# Access Compliance Report

## Public Rights-of-Way

### (Curb Ramps)

Intersection ID: 6154	Main Street: GORDON_WALTERS_DR	Cross Street: PERNELL_LN	Location: SE
ADA ID: F795CEF26841	Ramp Type: Perp	Initial Pass/Fail: Fail	Overall Compliance: No
Severity Score: 12.5			
Codes/Mitigation Info/Possible Solution		Field Measurements/Component Compliance

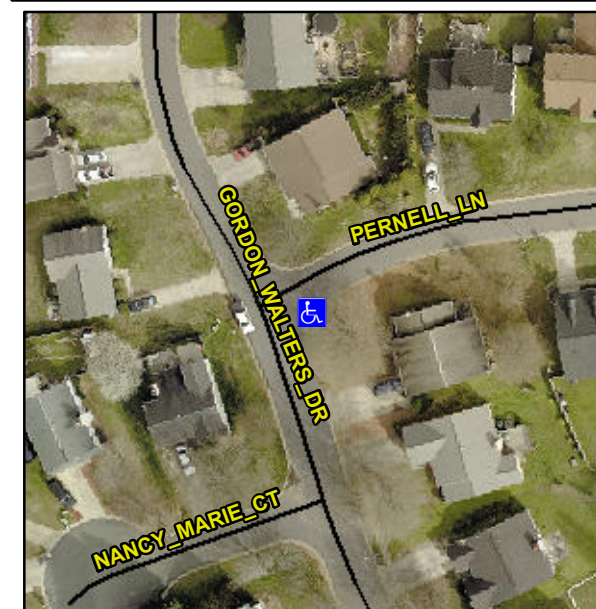
**R304.2.2**

Compliance	Description	Data	Compliance	Description	Data
N/A	Ramp Length (in)	38.5	No	Ramp Slope (%)	8.6
Yes	Ramp Width (in)	48.0	Yes	Ramp XSlope (%)	1.1
N/A	Flare Type LT	N/A	N/A	Flare Type RT	N/A
N/A	Flare Slope LT (%)	N/A	N/A	Flare Slope RT (%)	N/A
N/A	Flare Traversable LT?	N/A	N/A	Flare Traversable RT?	N/A
N/A	Landing Length (in)	N/A	N/A	DWS Provided?	N/A
N/A	Landing Width (in)	N/A	N/A	DWS Contrast?	N/A
N/A	Landing Slope (%)	N/A	N/A	DWS Length (in)	N/A
N/A	Landing X Slope (%)	N/A	N/A	DWS Full Width?	N/A
N/A	Landing Curb? (Y/N)	N/A	N/A	DWS Offset (in)	N/A
N/A	Shared Landing?	N/A			
N/A	Gutter Ponding?	N/A	N/A	Gutter Slope (%)	N/A
N/A	Gutter Lip Ht (in)	N/A	N/A	Gutter X Slope (%)	N/A
N/A	Painted X Walk1?	No	N/A	Painted X Walk2?	N/A
	X Walk 1 Direction	To N		X Walk 2 Direction	N/A
N/A	X Walk 1 Width (in)	N/A	N/A	X Walk 2 Width (in)	N/A
	X Walk 1 Slope (%)	3.5		X Walk 2 Slope (%)	N/A
	X Walk 1 X Slope (%)	2.5		X Walk 2 X Slope (%)	N/A

**Remove & Replace Entire Ramp.**
